UNITED STATES ENVIRONMENTAL PROTECTION AGENCY

Re: <u>LEHR/SCDS Superfund Site</u>

Draft Remedial Investigation Report, LEHR/SCDS Environmental Restoration, January 2003

Remedial Investigation Report, LEHR/SCDS Environmental Restoration, January 2003

Figure 7-7 Concentration Contour Plot (mg/L) - Hexavalent Chromium in HSU-1: 1995

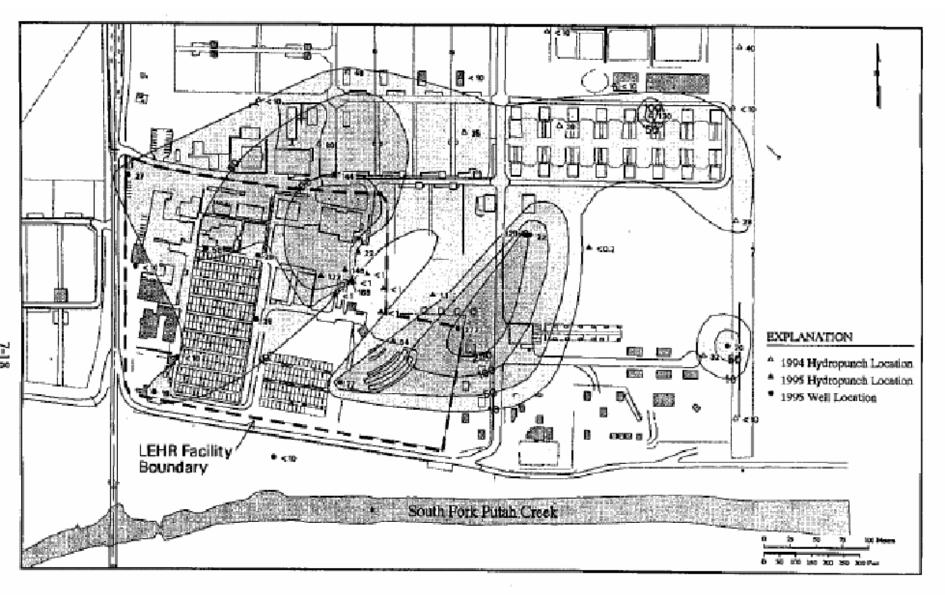
This discussion ignores the fact that UC Davis has detected Cr^{6+} in groundwater samples collected at the site at concentrations 30 times average background levels and that third party consultants (Jones & Stokes) have looked at UC Davis's data and drawn a Cr^{6+} plume flowing out of landfill 2. Table 1 appended to these comments contains data clearly indicating that site operations have degraded groundwater quality in both hydrostratigraphic 1 and 2 with inorganic contaminants. In order to provide a complete picture of the site conditions, please revise the RI Reportto include the following where appropriate,

There is evidence that a release of significant quantities of the known carcinogen (cancer-causing substance) hexavalent chromium has occurred at the site. It appears that Landfill Unit 2 is the source of hexavalent chromium in site groundwater, though a second major release of hexavalent chromium may have taken place in the vicinity of

monitoring well UCD1-028, where groundwater is currently affected at concentrations up to 3,000 times the California Public Health Goal (PHG) in Drinking Water (Office of Environmental Health HazardAssessment) for hexavalent chromium. It appears that this impacted water is migrating from shallow to deep groundwater as the concentrations of hexavalent chromium in the drinking water aquifer (HSU-2) are now up to 350 times the California PHG in Drinking Water, or four times the average background concentration. UC Davis is extracting the deep groundwater that has been impacted by this known carcinogen, treating it to remove volatile compounds, and then reinjecting this water into the drinking water aquifer up gradient of the location where the release of hexavalent chromium appears to have occurred. The treatment methodology being used to remove the volatile compounds does not remove any of the hexavalent chromium. Hence, it is expected that this cancer-causing compound is impacting groundwater in the drinking water aquifer upgradient of the extraction well.

Place this text into the RI Report immediately following any UC Davis discussion of hexavalent chromium in groundwater that implies or states that the hexavalent chromium detected in site groundwater is unrelated to site activities.
